Report to the DCA

DEVELOPMENT CONSENT AUTHORITY ALICE SPRINGS DIVISION

PROPOSED CONCURRENT APPLICATION PA2026/0151

Amendment proposal to rezone Lot 777 (8) Winnecke Avenue Town of Alice Springs
from Zone LR (Low Density Residential) to Zone LMR (Low-Medium Density Residential)

Figure 4 Proposed Planting Plan (Landscape Plan), DWG. A06, prepared by SD+A Architecture

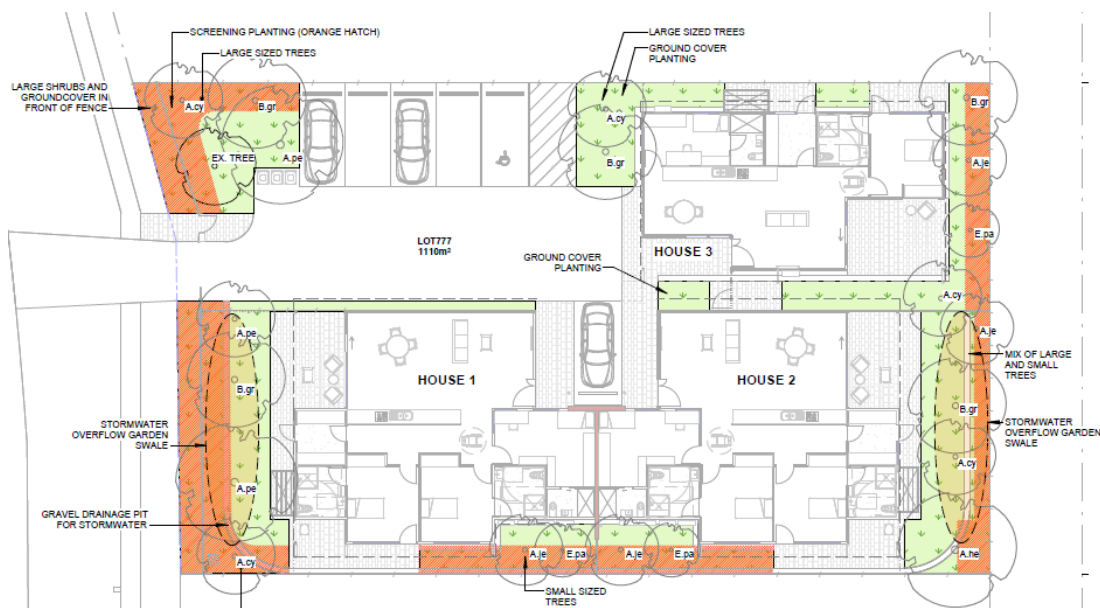
Where landscaping is required by the scheme sub-clause 3(d) guides that it should be designed to protect *significant trees and vegetation that contribute to the character and amenity of the site and the streetscape*. The applicant has opted to remove all existing vegetation, on site, except for an acacia tree within the northwest corner of the lot, fronting Winnecke Avenue. The site includes several established ghost gums, that contribute to onsite amenity and thermal cooling.

While the proposal in its current form would result in the removal of established trees, it does provide a significant level of new landscaping which:

- increases the number of trees on site
- supports deep soil planting for shade trees and
- is native and climate responsive.

The applicant's justification is considered sufficient to support the proposed variation and adequately addresses the reduction in the minimum landscaping requirement of 30%.

Figure 5 Proposed Street Frontage Elevation, showing planting, DWG. A10, prepared by SD+A Architecture

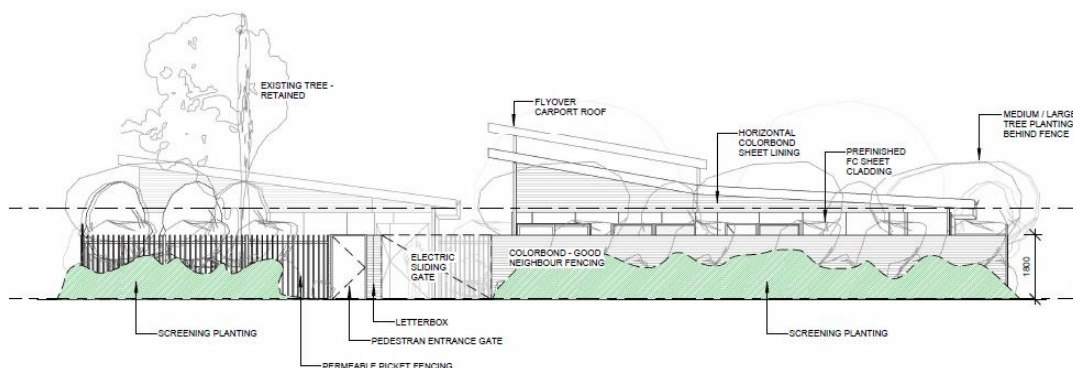
- The provision of landscaping to the front boundary to a depth of 1.2m that is in front of the proposed boundary fencing, which supports streetscape amenity and improves integration of the development with the street (See Fig 7 and 8).
- There is a total area of 175sqm on site for deep soil planting of medium-large trees.
- As the development provides for disability access to internal and external areas, there is a greater need for hard surfacing and wider external access paths.
- The design incorporates planting of medium to large trees that will provide shade to external hard surfaces.

Figure 6 Proposed distance between residential buildings on site (measured by DAS), DWG. A04, prepared by SD+A Architecture

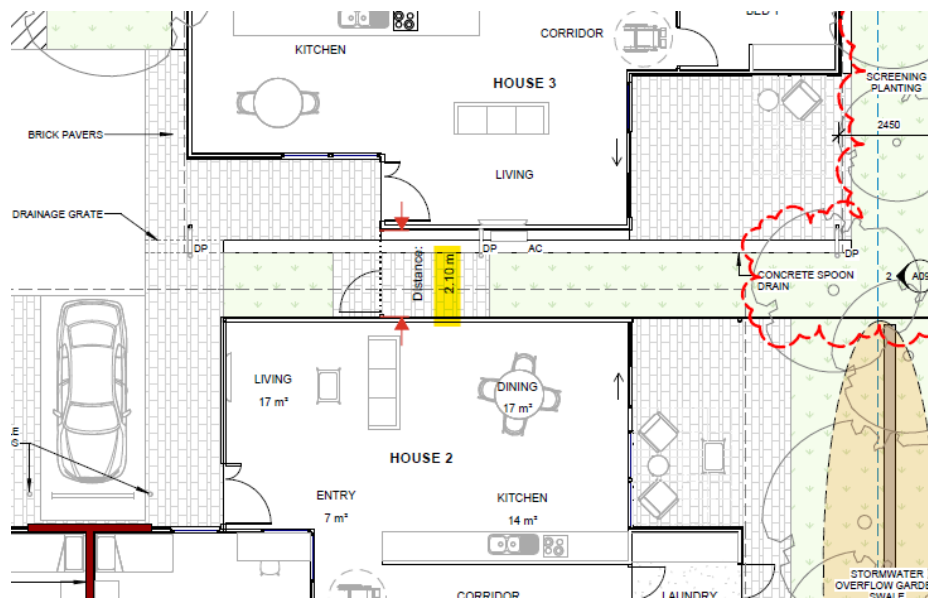
A variation to this clause is considered acceptable for the following reasons:

- There are no openings at ground level in the external facing walls between the two buildings, which reduces perceived and actualised effects of building massing.
- Building massing is also minimised through the varying roof form, material selection and recessing external walls at the front and rear of the buildings.
- The proximity of buildings does not result in opportunities of overlooking into adjoining private open space, where views are obstructed by an internal good neighbour boundary fence to a height of 1.8m.

Figure 8 Length of building line (House 3) at North Elevation, DWG. A04, prepared by SD+A Architecture

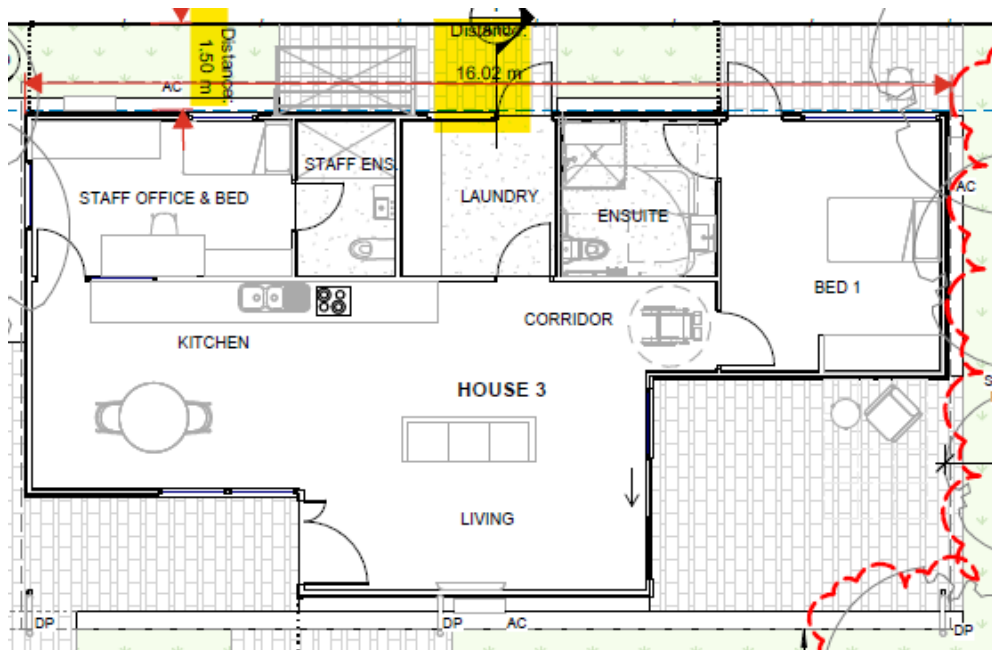
Taken together, the above factors reduce the effects of building massing and bulking of the proposed development, when viewed from the adjoining lot.
